<b>Notice of Allowability</b>	<b>Application No.</b>	<b>Applicant(s)</b>	
	10/626,491	JAUSSI ET AL.	
	<b>Examiner</b>	<b>Art Unit</b>	
	Terry L. Englund	2816

REPLACEMENT SHEET  
 Page 1 of 6  
 FILTERING VARIABLE OFFSET AMPLIFIER  
 James E. Jaussi et al.  
 10/626,491  
 10559-554002

FIG. 1

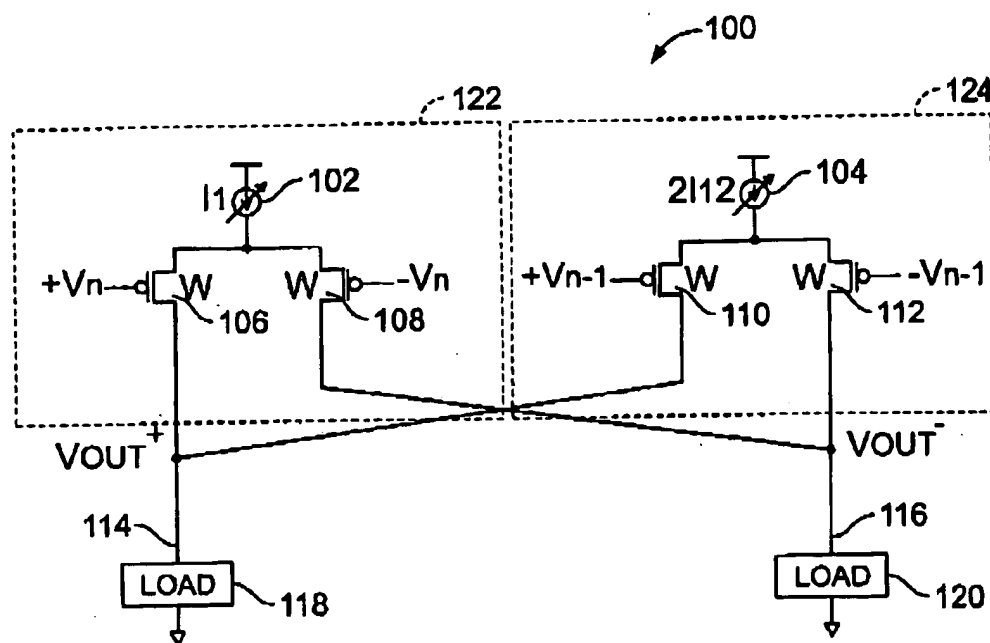
In Figs. 1-5, the Applicants have added labels to identify  $V_{out+}$  and  $V_{out-}$ .

FIG. 2

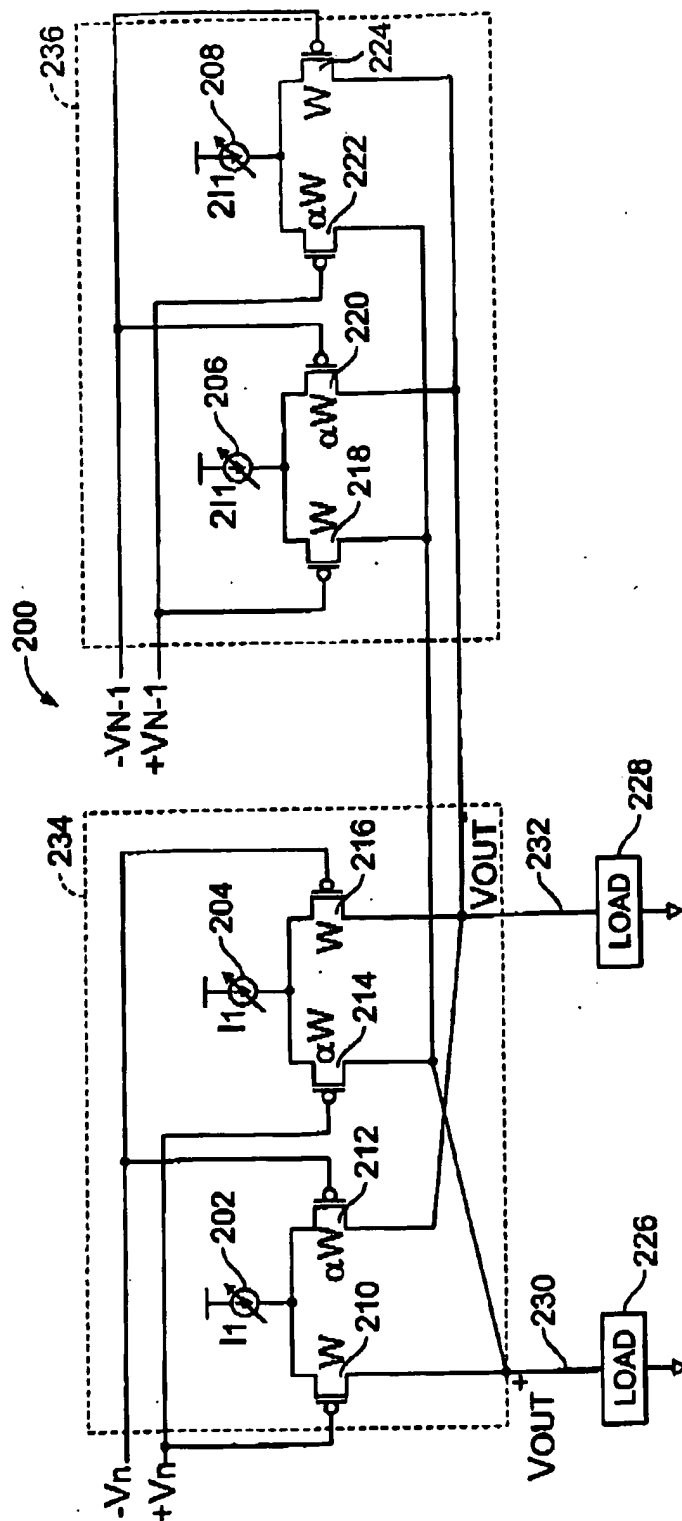
In Fig. 2, the Applicants have shown the configuration described in the specification by swapping the inputs labeled  $V_{N-1+}$  and  $V_{N-1-}$ .
